Access Compliance Report Public Rights-of-Way (Curb Ramps)

Intersection ID: 6045Main Street:ROSEMALLOW_RDCross Street:BACK_CREEK_CHURCH_RDLocation:NEADA ID: 72557EAB33D8Ramp Type:PerpInitial Pass/Fail:FailOverall Compliance:NoSeverity Score:25

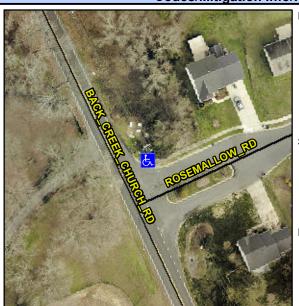
Field Measurements/Component Compliance Compliance Description Data Compliance Description Data					
N/A	Ramp Length (in)	96.0	Yes	Ramp Slope (%)	7.1
Yes	Ramp Width (in)	71.0	No	Ramp XSlope (%)	11.2
N/A	Flare Type LT	/ 1.0 N/A	N/A	Flare Type RT	N/A
N/A	Flare Slope LT (%)	N/A	N/A	Flare Slope RT (%)	N/A
N/A N/A	Flare Traversable LT?	N/A N/A	N/A N/A	Flare Traversable RT?	N/A N/A
N/A	Landing Length (in)	N/A	N/A	DWS Provided?	N/A
N/A	Landing Width (in)	N/A	N/A	DWS Contrast?	N/A
N/A	Landing Slope (%)	N/A	N/A	DWS Length (in)	N/A
N/A	Landing X Slope (%)	N/A	N/A	DWS Full Width?	N/A
N/A	Landing Curb? (Y/N)	N/A	N/A	DWS Offset (in)	N/A
N/A	Shared Landing?	N/A			
N/A	Gutter Ponding?	N/A	N/A	Gutter Slope (%)	N/A
N/A	Gutter Lip Ht (in)	4.0	N/A	Gutter X Slope (%)	N/A
N/A	Painted X Walk1?	No	N/A	Painted X Walk2?	N/A
	X Walk 1 Direction	To S		X Walk 2 Direction	N/A
N/A	X Walk 1 Width (in)	N/A	N/A	X Walk 2 Width (in)	N/A
	X Walk 1 Slope (%)	2.4		X Walk 2 Slope (%)	N/A

X Walk 1 X Slope (%)	9.3		X Walk 2 X Slope (%)	N/A
N/A	Ramp inside XWalk1?	N/A	N/A	Ramp inside XWalk2?	N/A
	Road Slope (%)	N/A	N/A	Clear Space?	N/A
	Road X Slope (%)	N/A	N/A	Clear Space to XWalk (in)	N/A
N/A	Any Obstructions?	N/A	N/A	Storm Grate/Utility Hazard?	N/A
	Obstruction Type			Storm Grate/Utility Type	
		N/A			N/A
			Yes	Surface Condition? (G/P)	Good
1000	S. S. Carrier	'	•	, ,

Codes/Mitigation Info/Possible Solution

Total Cost: \$ 1850.00
